POWER PLANT - ENGINE - INCORPORATE REVISED CLIPPING REQUIREMENTS AT CP0789 - CATEGORY
CODE 4 - MOD.ENG-71-0056

V2500-ENG-71-0056

Location of the clipping point VP0789
Fig.1

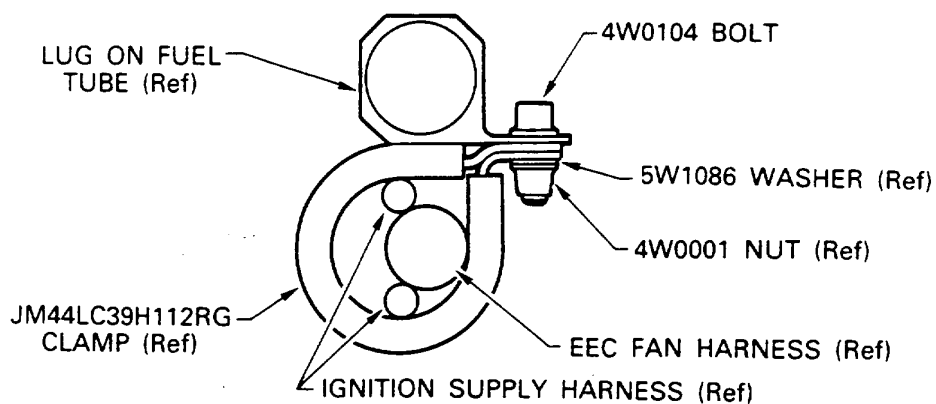
- (a) At clipping point CP0789, an additional spacer has been introduced to give the sufficient clearance between the Harnesses and the Fuel Tube. (See Figure 1).
- (b) At clipping point CP0789, the Bolt has been lengthened in line with the additional spacer. (See Figure 1).

- (1) Find the clipping point CP0789 where is located near the Oil Tank. (refer to Figure 1).
- (2) At CP0789, remove 4W0001, Nut, 5W1086, Washer, JM44LC39H112RG, Clamp. and 4W0104, Bolt, from the Harnesses and the Lug on Fuel Tube. (refer to Figure 2).
- (3) At CP0789, install JM44LC39H112RG, Clamp, new 5W1029, Spacer, 5W1086, Washer, new 4W0107, Bolt, and 4W0001, Nut, to the Harnesses and the Lug on Fuel Tube. (Refer to Figure 2).
- (4) At CP0789, torque the Nut to 36 - 40 lbfin (4,07 - 4,52 Nm). (Refer to Figure 2, and Aircraft Maintenance Manual, 70-23-11, Torque Tightening Technique).

Clipping Detail at CP0789 – Before and After alteration
Fig.2

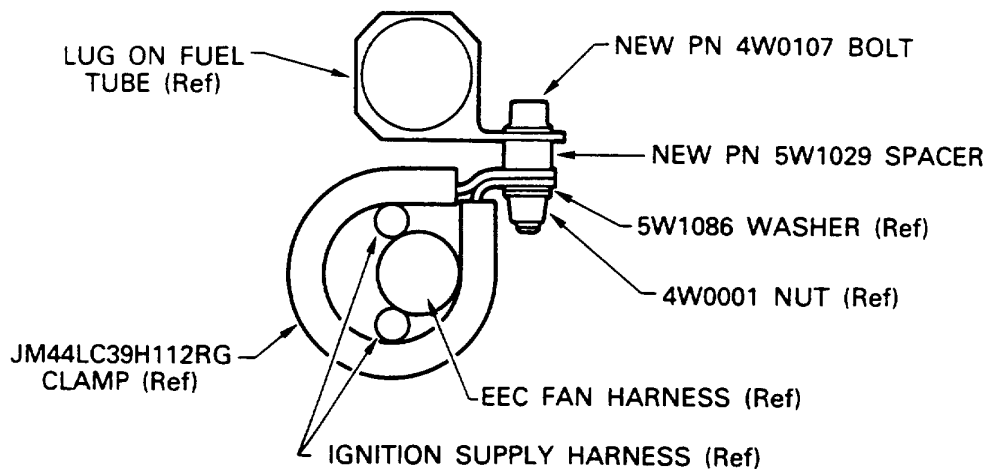
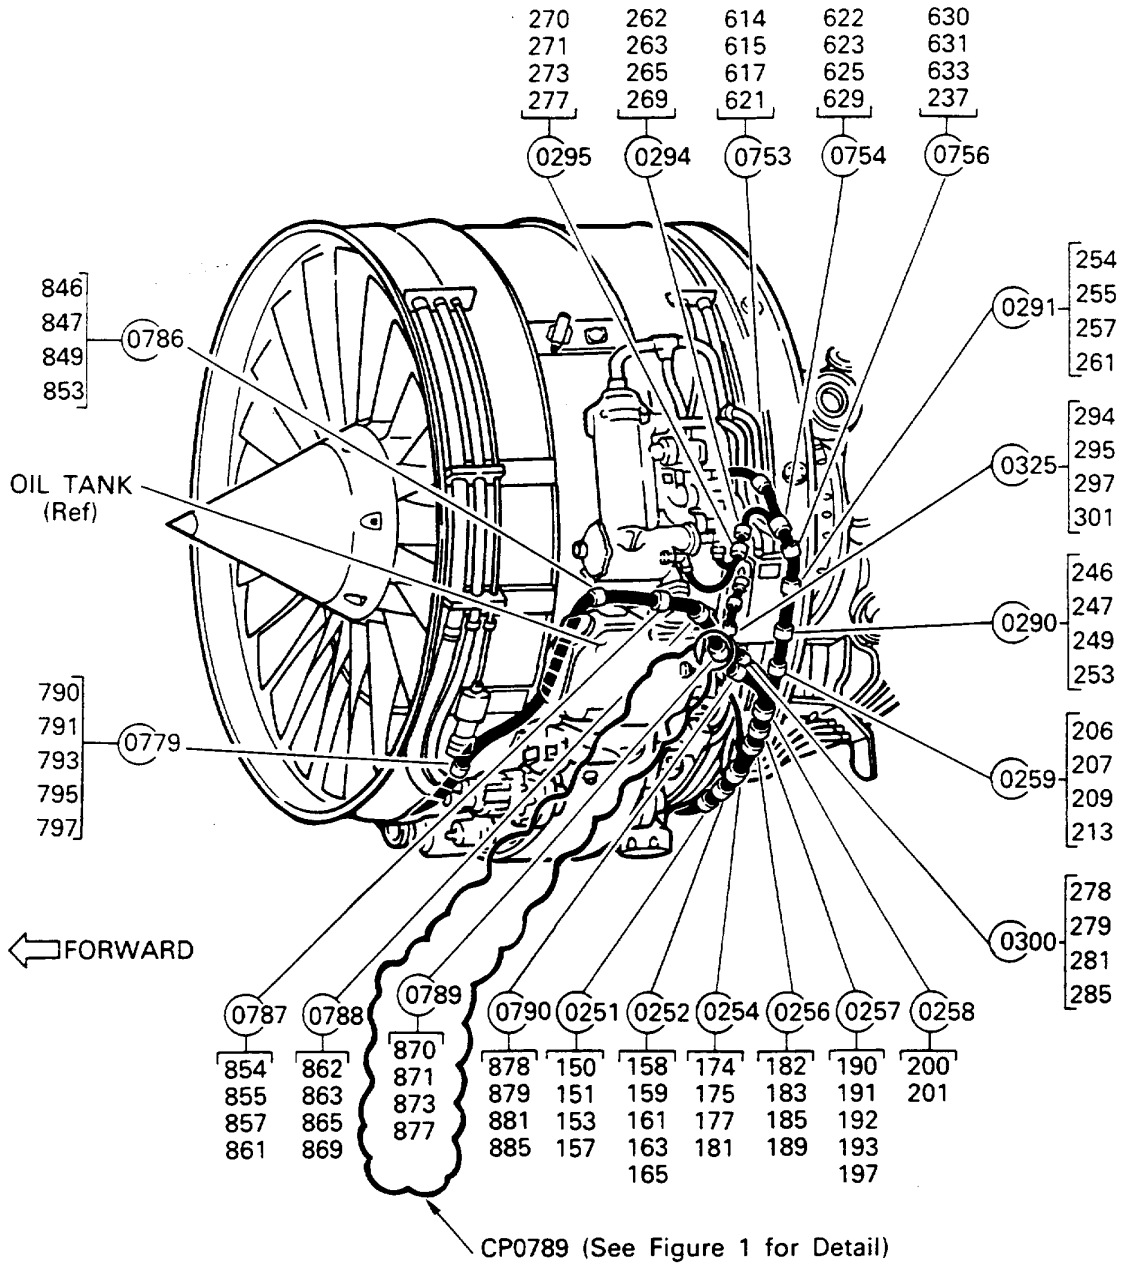
The EEC Fan Harness and the Ignition Supply Harness may not have sufficient clearance with the Fuel Tube as they approach clipping point CP0789. This may cause the Harnesses to contact to the Fuel Tube.

A review of the Harnesses clipping has shown that an additional spacer is necessary at clipping point CP0789 to ensure the adequate clearance between the Harnesses and the Fuel Tube.
